|    | Summary of Matters Raised                                                                                                                              | Proponent's Response

*Figure 2: Aerial image of the site, location of development highlighted in red, dated 6 April 2019 (Source: Nearmap)*

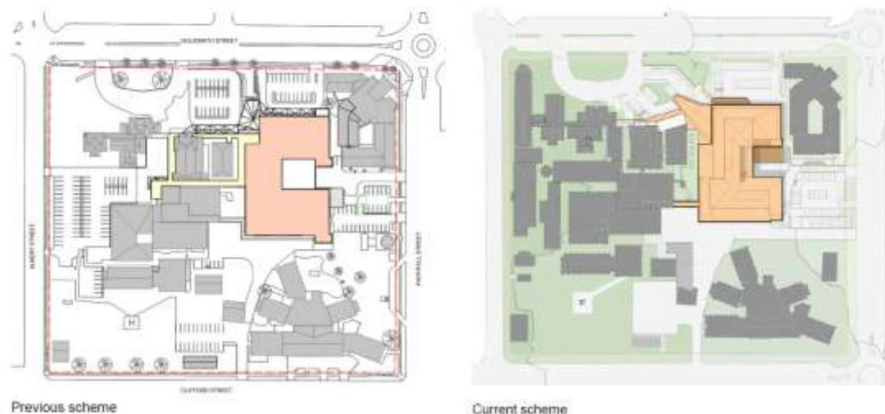
|    | Summary of Matters Raised                                                                                                                              | Proponent's Response                                                                                                                                                                                                                                                                                                                                                                                                                                                                                                                                                                                                                                                                                                                                                                                                                                                                                                                                                                                                                                                                                                                                                                                                                                                                                                                                                                                                                                                                |
|----|--------------------------------------------------------------------------------------------------------------------------------------------------------|-------------------------------------------------------------------------------------------------------------------------------------------------------------------------------------------------------------------------------------------------------------------------------------------------------------------------------------------------------------------------------------------------------------------------------------------------------------------------------------------------------------------------------------------------------------------------------------------------------------------------------------------------------------------------------------------------------------------------------------------------------------------------------------------------------------------------------------------------------------------------------------------------------------------------------------------------------------------------------------------------------------------------------------------------------------------------------------------------------------------------------------------------------------------------------------------------------------------------------------------------------------------------------------------------------------------------------------------------------------------------------------------------------------------------------------------------------------------------------------|
| 1. | Provide confirmation that the proposed modification will not increase the impact on biodiversity values in accordance with section 7.17 of the BC Act. | <p>Pursuant to Section 7.17(2) of the Biodiversity Conservation Act 2016, a Biodiversity Development Assessment Report (BDAR) is required to be submitted for modified applications, unless the consent authority is satisfied that the modification will not increase the impact on biodiversity values.</p> <p>The original Environmental Impact Statement (EIS) was accompanied by waivers from the Planning Agency Head (dated 19 January 2018) and the Environment Agency Head (dated 8 December 2017), which determined that there was no need to submit a BDAR, as the development was not likely to have any significant impact on biodiversity values.</p> <p>The revised built form, incorporates a similar building envelope and footprint, retaining the approved "u-shape" envelope (refer to Figure 1). The proposed modifications also include a reduction of Gross Floor Area (GFA), from 12,072 sqm (approved) to 11,744 sqm (proposed) which is a reduction of 328 sqm.</p> <div data-bbox="660 817 1541 1232">  </div> <p><i>Figure 1: Comparison of approved (left) vs proposed (right) scheme (Source: Silver Thomas Hanley)</i></p> <p>The modified building envelope does not require the removal of any additional trees. As outlined in Figure 2, the part of the site where the new building is proposed, is void of any vegetation. Additionally, the site is not</p> |

We therefore confirm that the modified building envelope will not increase the impact on biodiversity values on the site and EES's assessment, in granting waivers for the approved development, still remain valid and applicable to the proposed modification application.

Figure 3: Extract from Wayfinding and Signage Plans (Source: Minale Tattersfield)

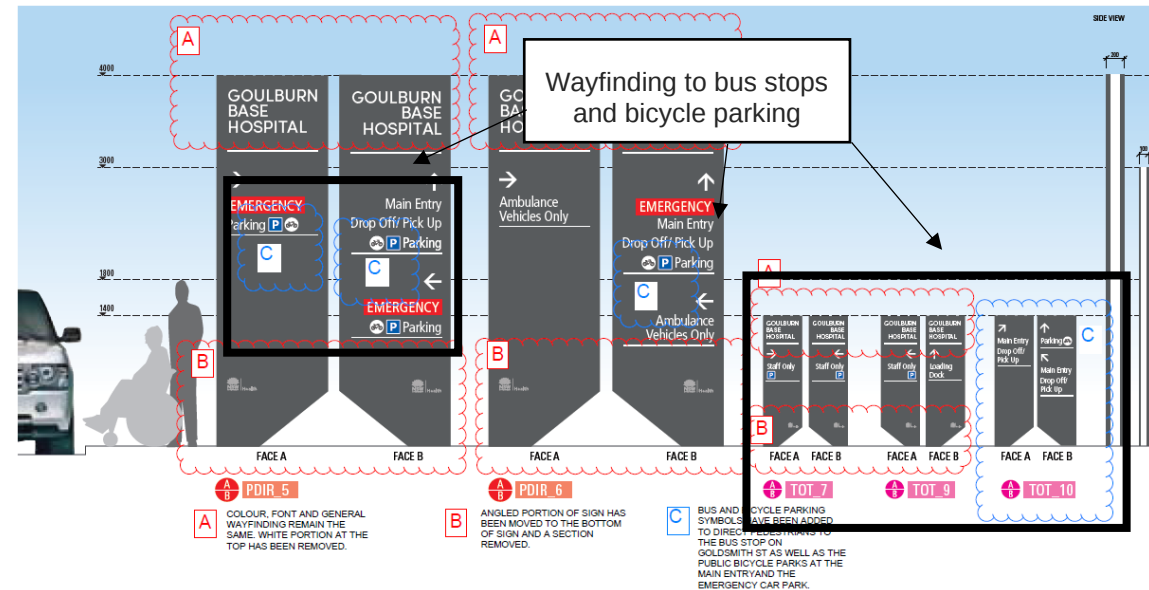
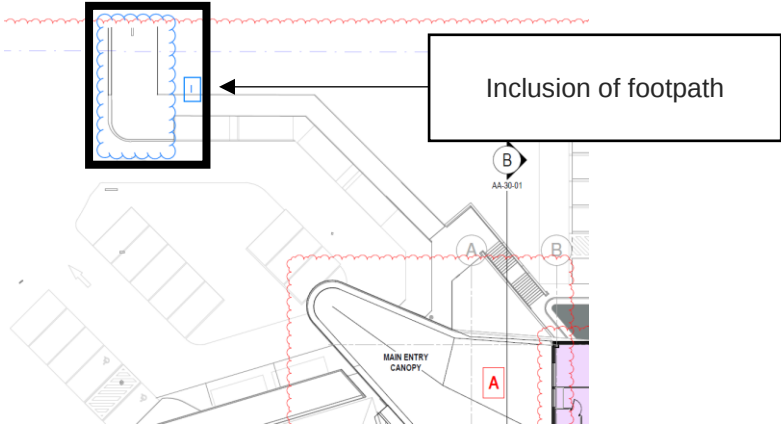
2. Include wayfinding strategies and travel access guides along with the signage modifications to assist with increasing the mode share of walking, cycling and public transport. It is recommended that wayfinding to the nearby bus stops at Goldsmith St and Albert St is included.

The Wayfinding and Signage Plans have been updated by Minale Tattersfield (Appendix 1) to include appropriate signage, guiding the hospital's visitors to the surrounding bus stops along Goldsmith and Albert Streets to encourage the use of public transportation. The proposed signage has also been amended to include wayfinding to the public bicycle parking areas, to encourage visitors to cycle to and from the hospital.
